Meeting Agenda

Historic Zoning Commission

Monday, November 14, 2022

A SITE PLAN (FRONT YARD)

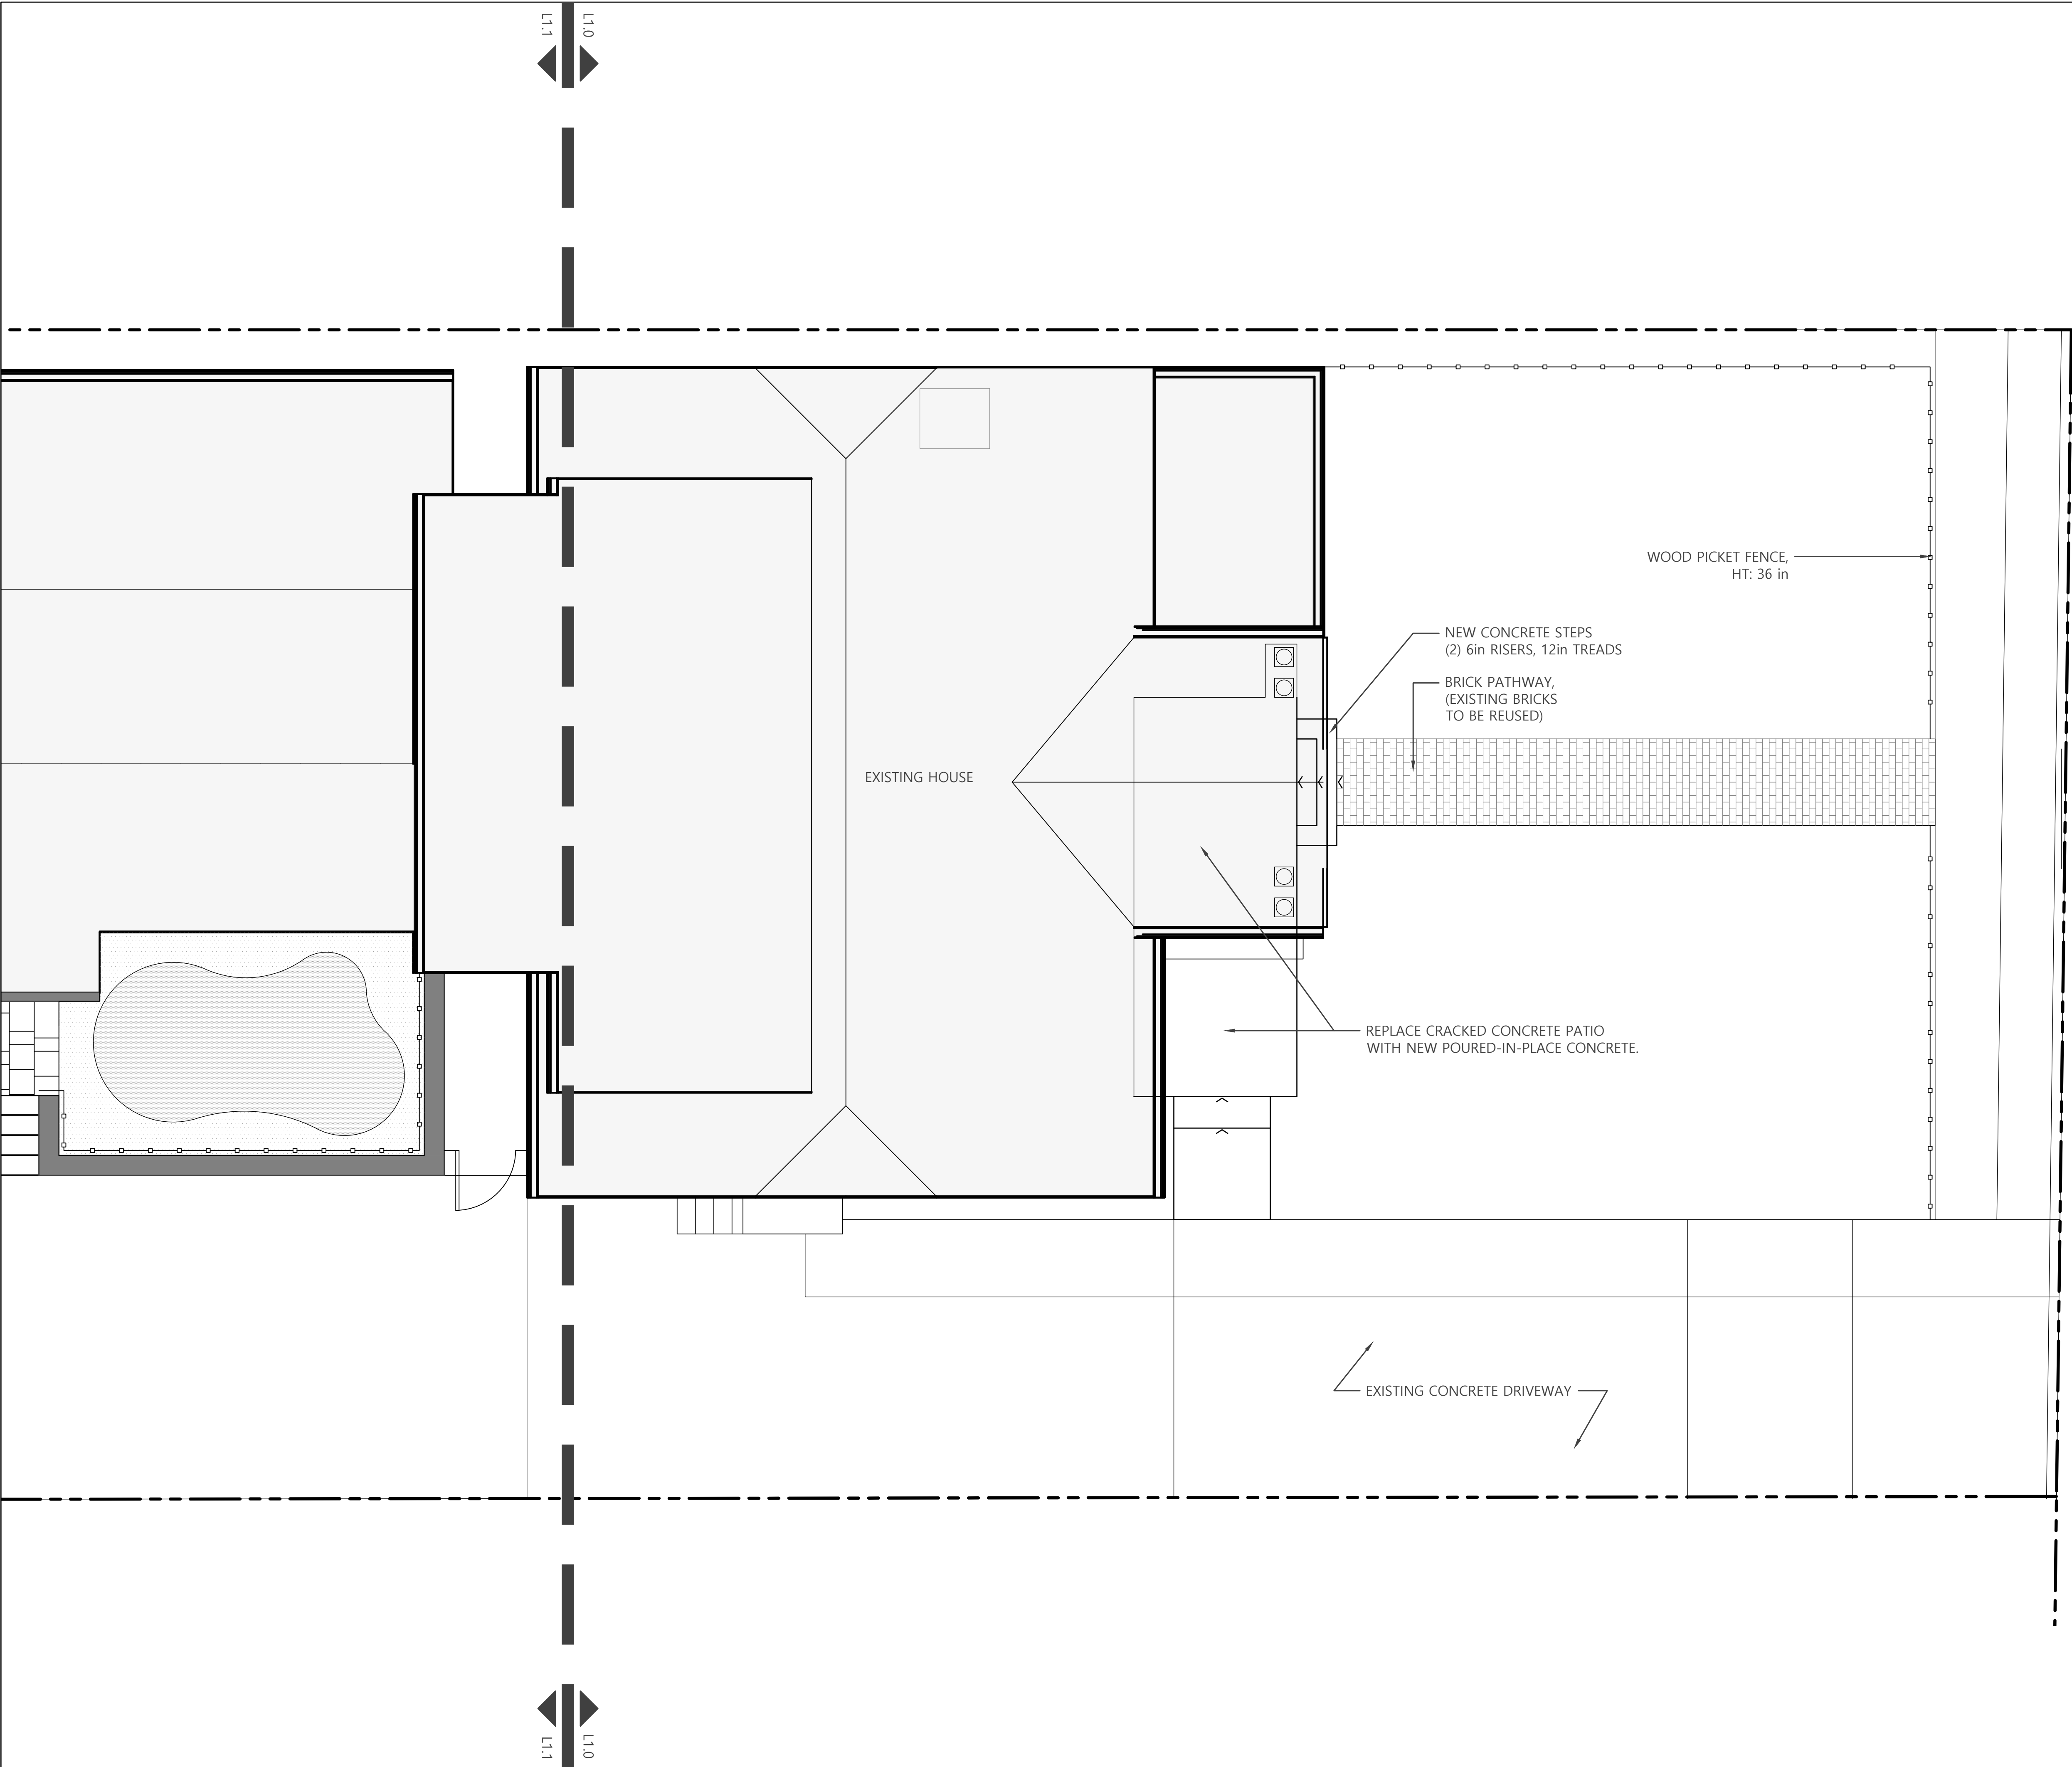
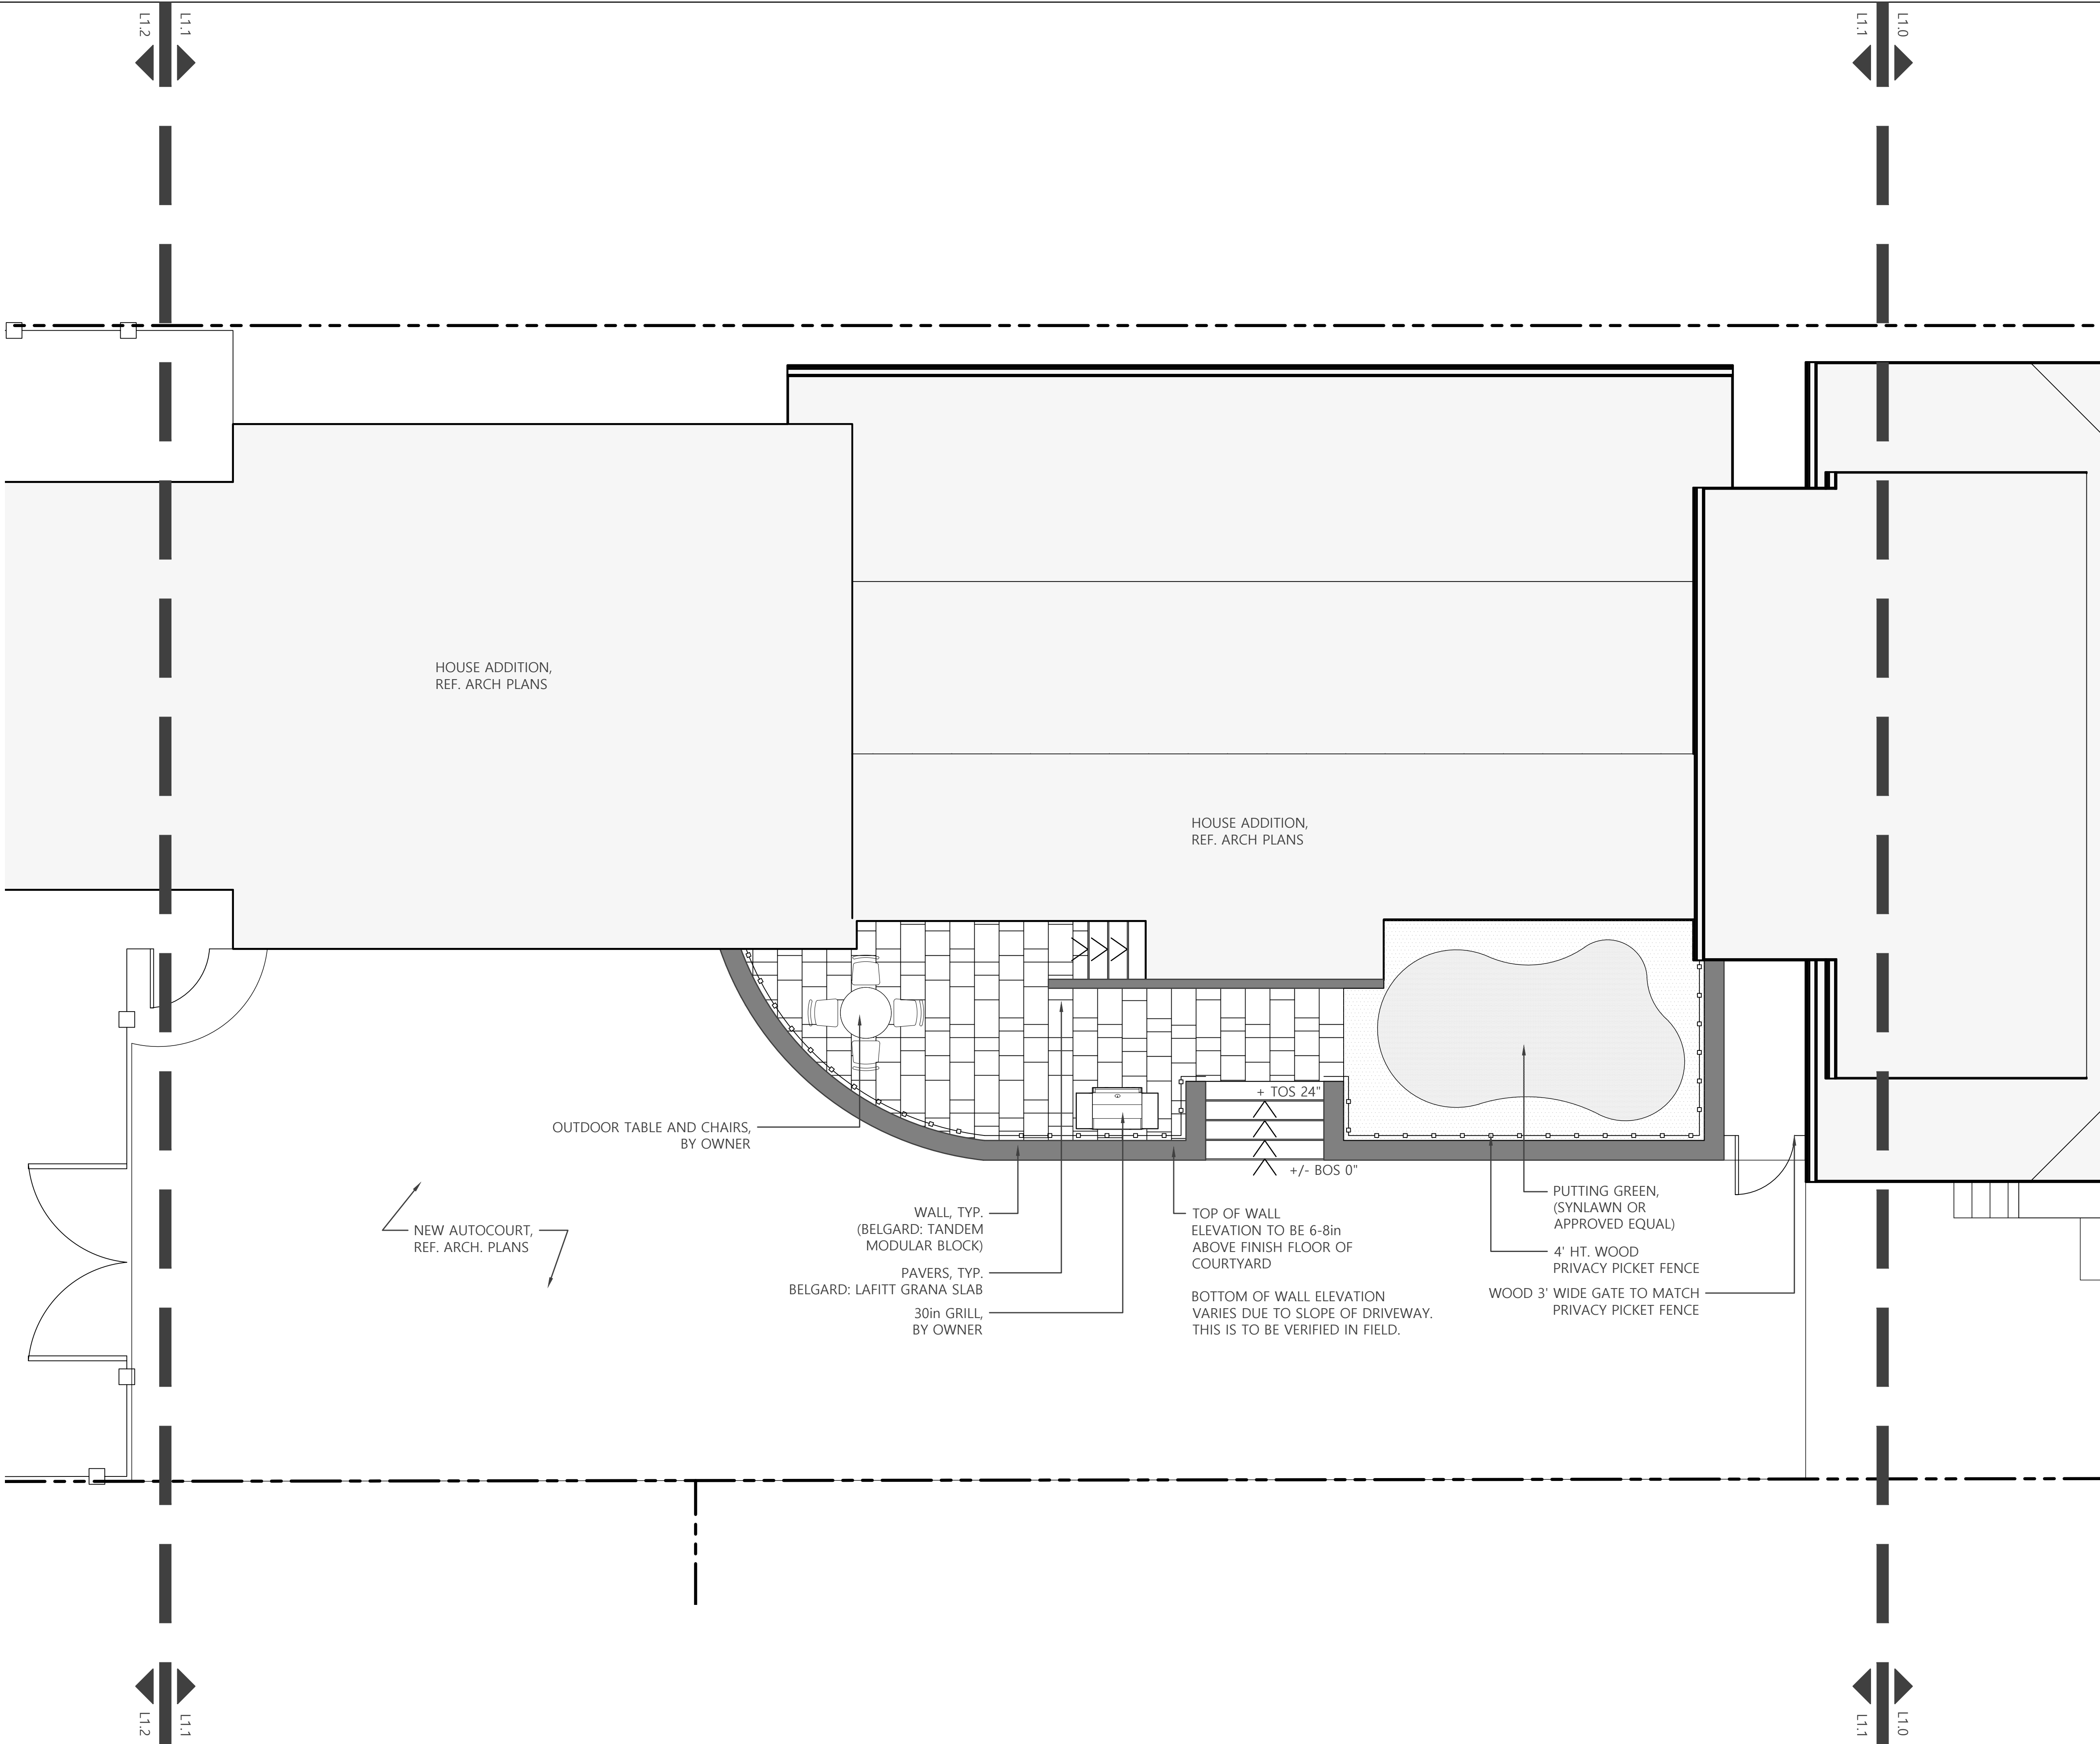
The purpose of this memorandum is to provide information to the Historic Zoning Commission concerning the placement of front yard fencing at 906 Fair St.

1. If a gate is proposed for placement at the location of the front walkway, it must be configured to swing inwardly, per Guidelines. The design of the gate must be submitted to the Preservation Planner for review and approval in light of the applicable Guidelines prior to work commencing.
2. All conditions of approval previously issued for the rear yard fencing remain in effect.
3. The application must meet all the requirements of the Building & Neighborhood Services Department prior to issuance to work commencing, and any additional changes to the approved plans must be returned to the Preservation Planner or the HZC for review and approval.
